The Commission has issued the enclosed Amendment No. 98 to Facility Operating License No. DPR-59 for the James A. FitzPatrick Nuclear Power Plant. The amendment consists of changes to the Technical Specifications in response to your request dated October 11, 1985.

The amendment revises the Technical Specifications to (1) permit reactor operation with one recirculation loop out of service and (2) include General Electric Company's Service Information Letter (SIL) No. 380, Revision 1 recommendations regarding thermal-hydraulic stability for dual loop and single loop operation.

AMENDMENT TO FACILITY OPERATING LICENSE

Amendment No. 98
License No. DPR-59

Figure 3.5-1
Thermal Power and Core Flow Limits of
Specifications 3.5.J.1, 3.5.J.2 and 3.5.J.3

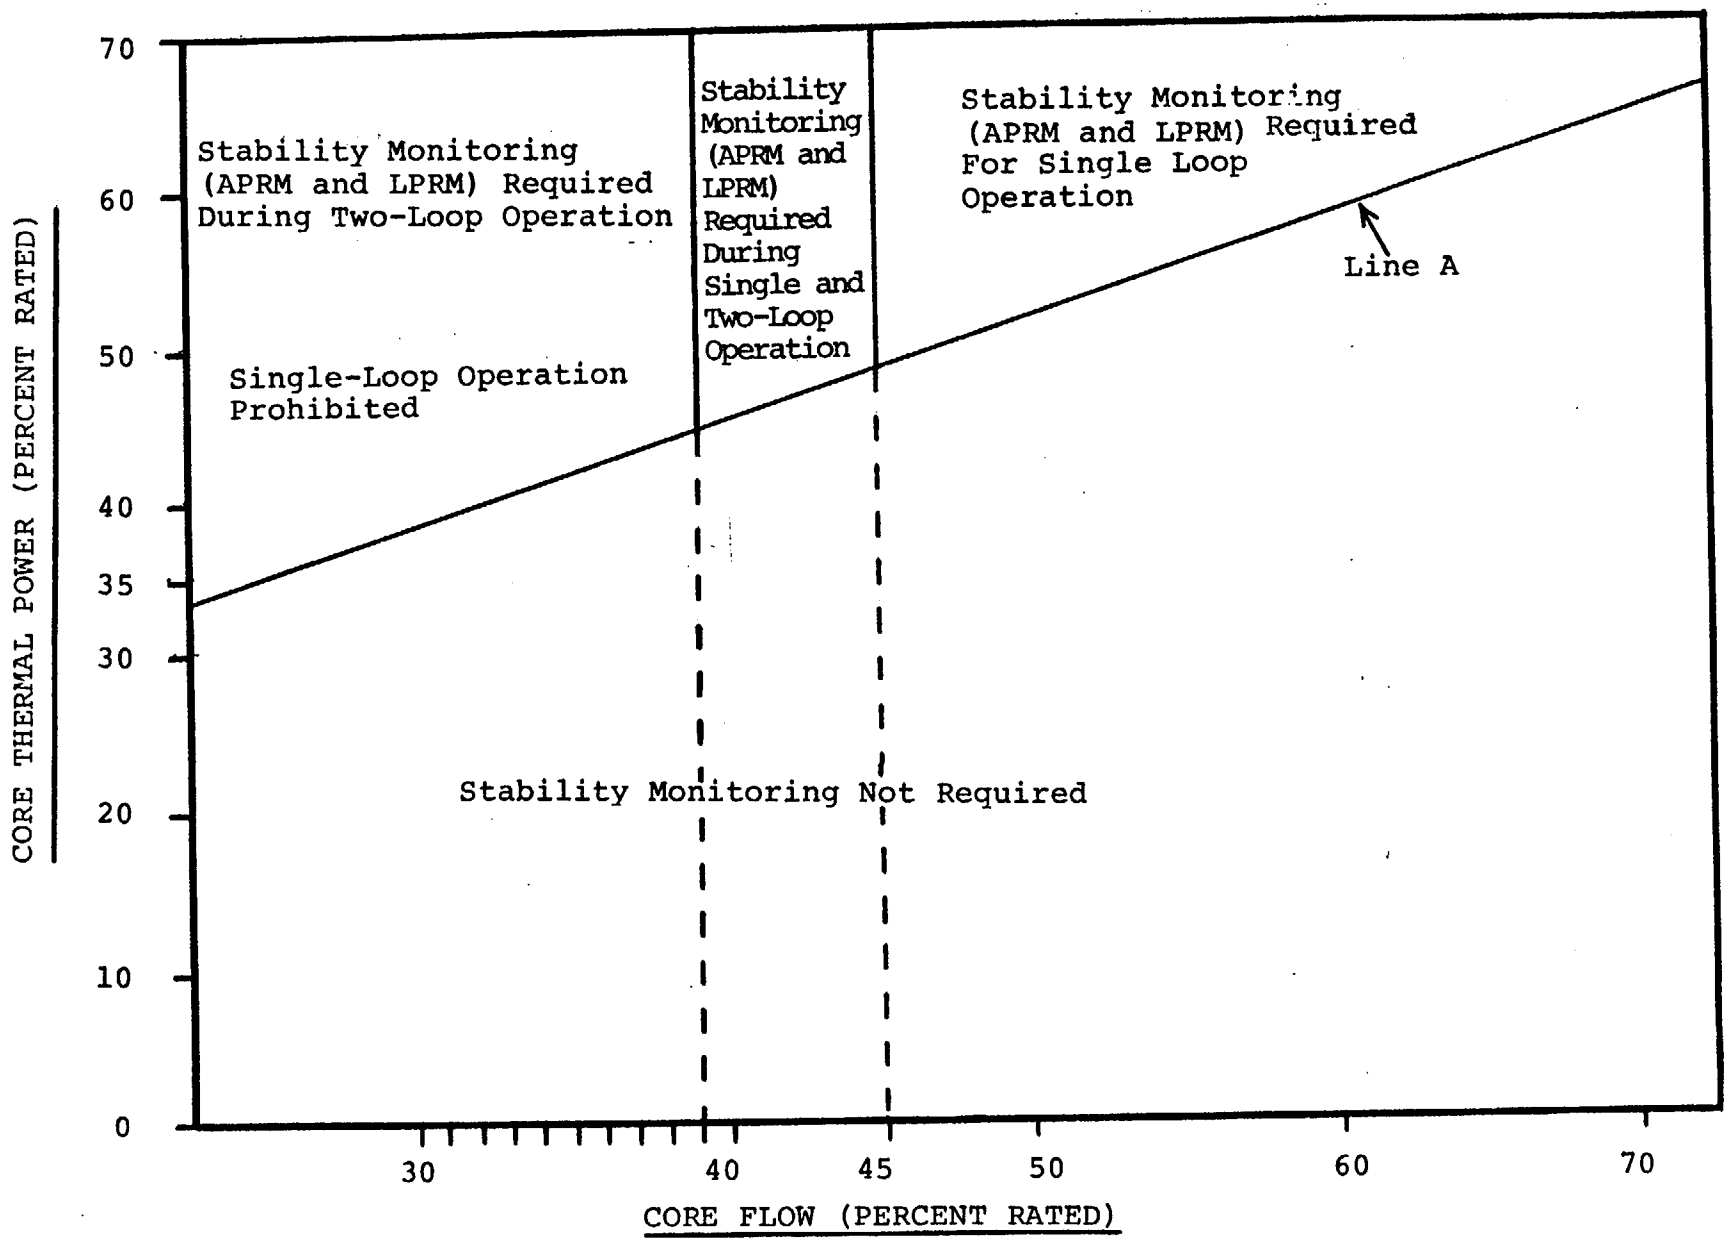
5. Specifications 3/4.5.J, including Figure 3.5-1, have been added to provide operating limits and surveillance requirements for thermal-hydraulic stability. These TS implement the recommendations of SIL 380 and are similar to other approved TS (References 7 and 8). These TS set up appropriate power-flow regions, time frames, and action levels for establishing baseline and active monitoring of LPRM and APRM levels for both one and two loop operation.

2. With two Reactor Coolant System recirculation loops in operation and total core flow less than 45 percent of rated, and thermal power greater than the limit specified in Figure 3.5-1 (Line A); or with one Reactor Coolant System loop operating and thermal power greater than the limit specified in Figure 3.5-1 (Line A):

3. If during single-loop operation, core thermal power is greater than the limit defined by line A of Figure 3.5-1, and core flow is less than 39 percent, immediately initiate corrective action to restore core thermal power and/or core flow to within the limits, specified in Figure 3.5-1, by increasing core flow and/or initiating an orderly reduction of core thermal power by inserting control rods.

Figure 3.5-9

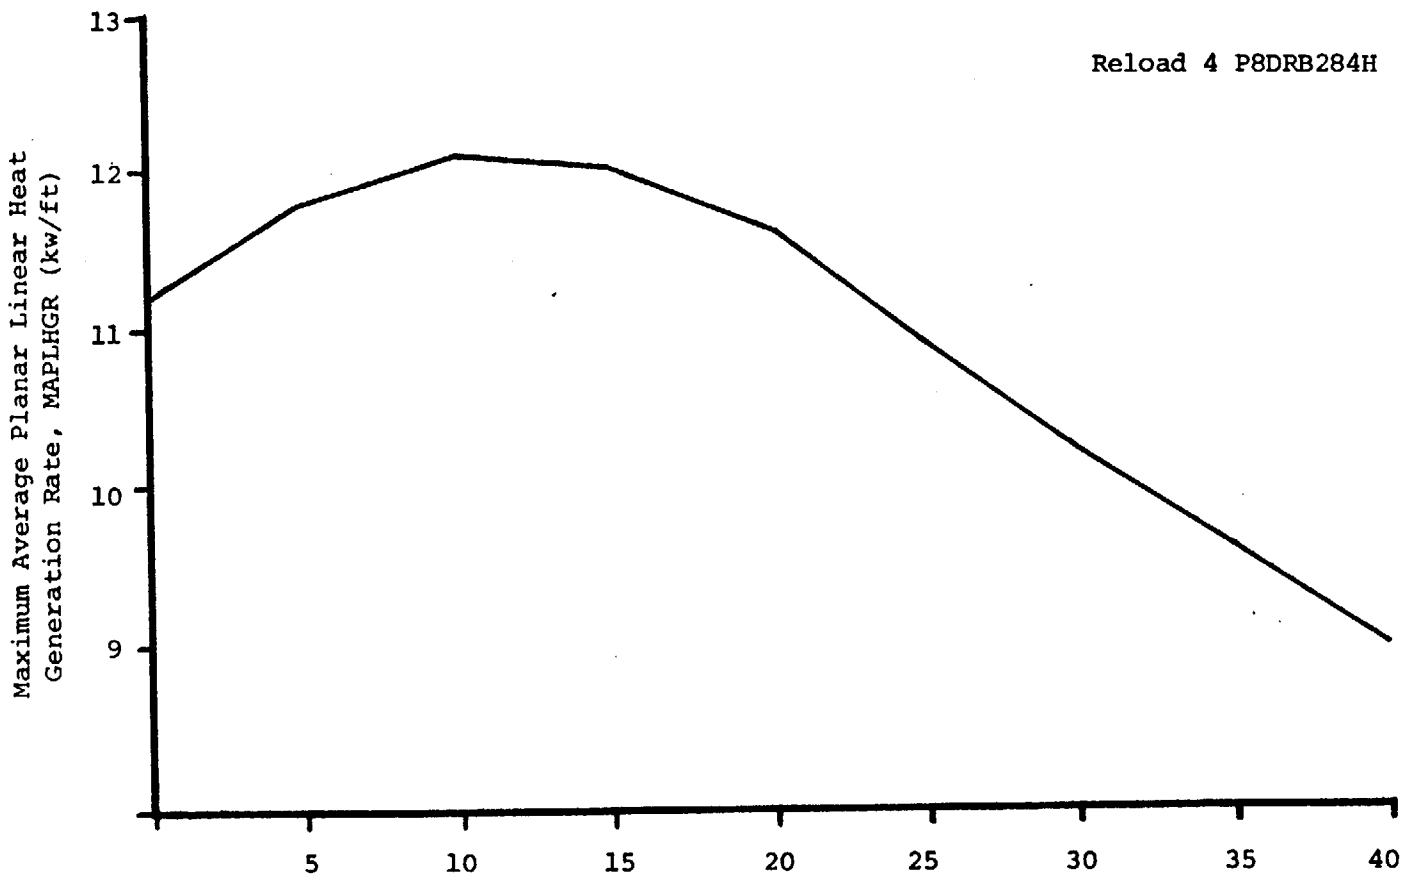
For single-loop operation, these MAPLHGR values are multiplied by 0.84.

Figure 3.5-10

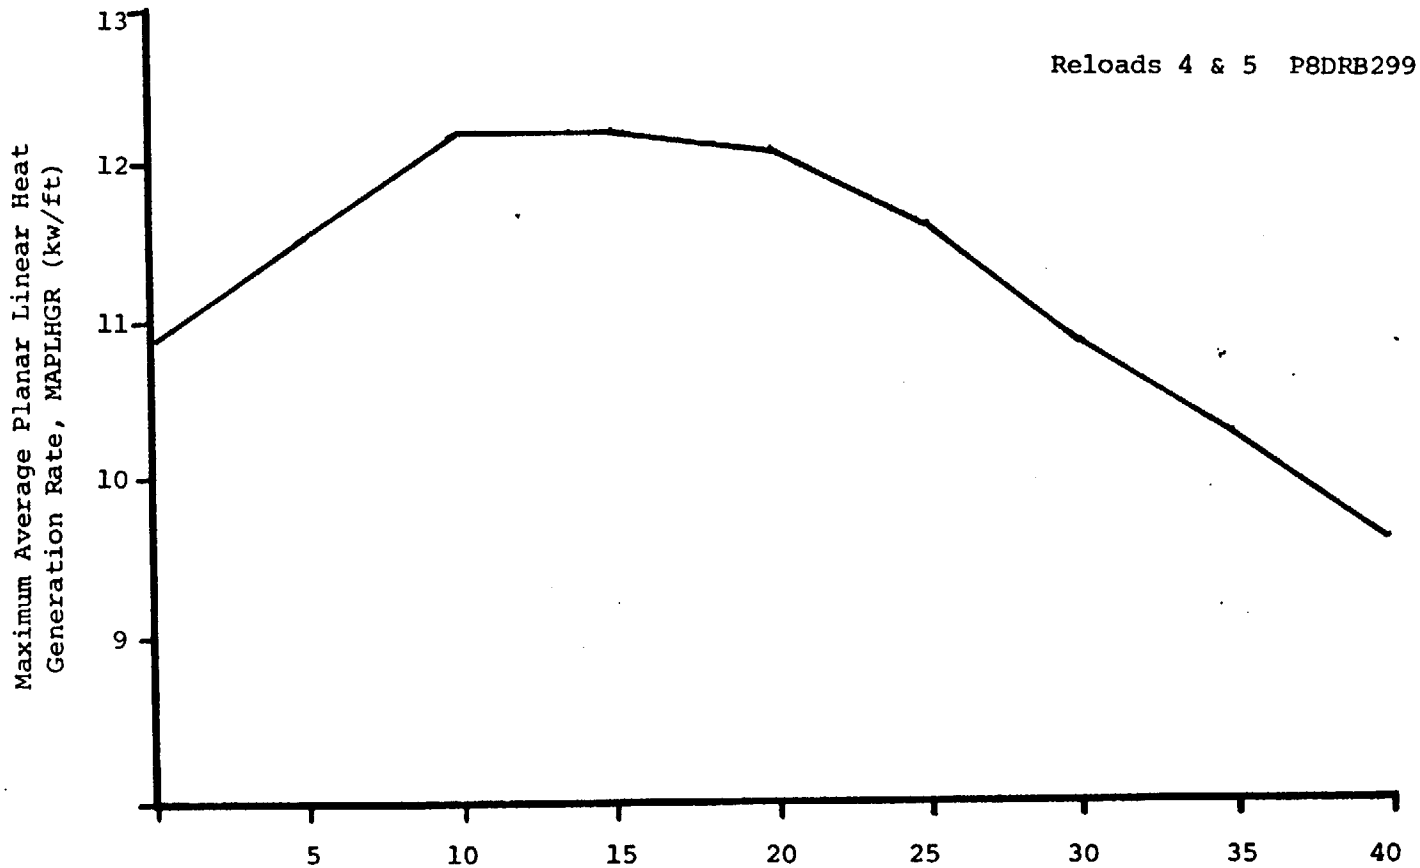
For single-loop operation, these MAPLHGR values are multiplied by 0.84.

Figure 3.5-11

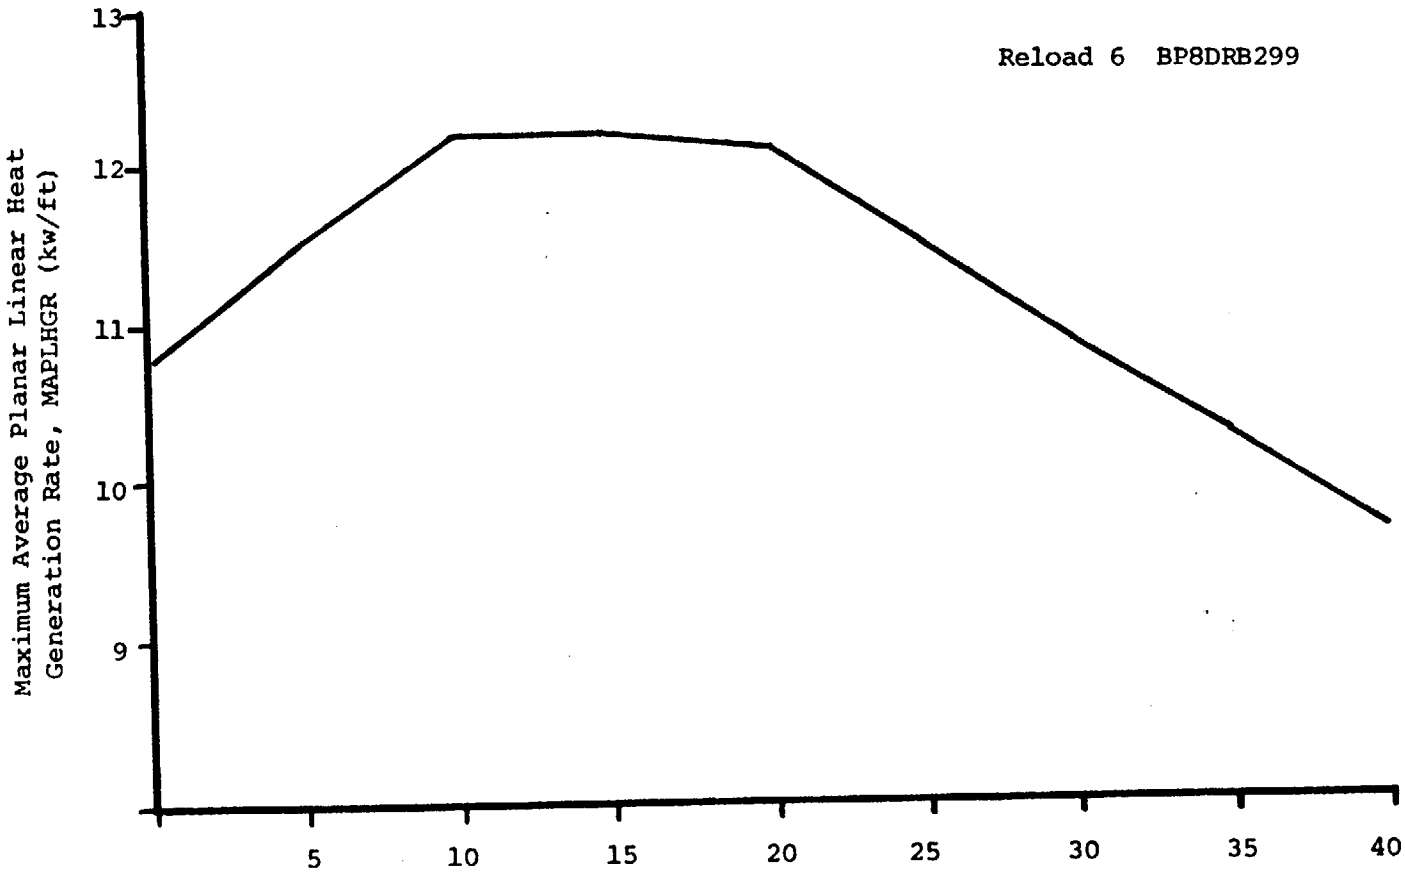
For single-loop operation, these MAPLHGR values are multiplied by 0.84.
